# UNITED STATES PATENT AND TRADEMARK OFFICE

10/824,942

Mitsuhiko Otani

<b>Office Action Summary</b>	<b>Application No.</b> 10/824,942	<b>Applicant(s)</b> OTANI, MITSUHIKO	
	<b>Examiner</b> Mohammad Timor Karimy	<b>Art Unit</b> 2815

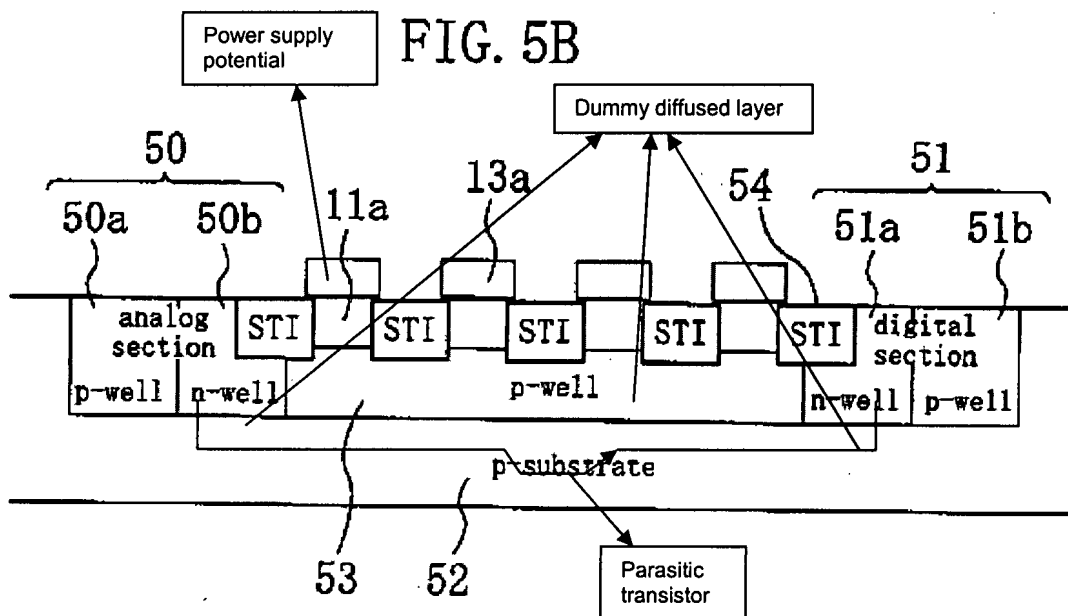
Ishikura discloses in figure 5B, a semiconductor integrated circuit device, comprising a digital circuit 51 and an analog circuit 50 that are disposed on a surface of a semiconductor substrate 52.

wherein a dummy layer part 13a made of polysilicon that is the same as polysilicon composing a gate of a transistor is disposed directly on a portion of the semiconductor substrate being of higher resistance than a well region between the digital circuit 51 and the analog circuit 50 (Ishikura explicitly teaches in paragraphs [16-17] that P-type region 52 has increased resistance due to analog and digital regions being sufficiently spaced away from one another (note that region 52 is under the dummy gate layers 13a)), and

a dummy diffused region is provided between an area under the dummy layer part and one of the digital circuit part and the analog circuit part, with a power-supply potential being applied to the dummy diffused region (see figure 5B below).

Furthermore, note that Ishikura's device presents a structure that reads on applicant's claim as discussed above, and as such a parasitic transistor may exist in Ishikura's device between a collector and an emitter as well (see illustrations on figure 5B below).

Furthermore, note that Ishikura's device presents a structure that reads on applicant's claim as discussed above, and as such a parasitic transistor may exist in Ishikura's device between a collector and an emitter as well (see illustrations on figure 5B above).
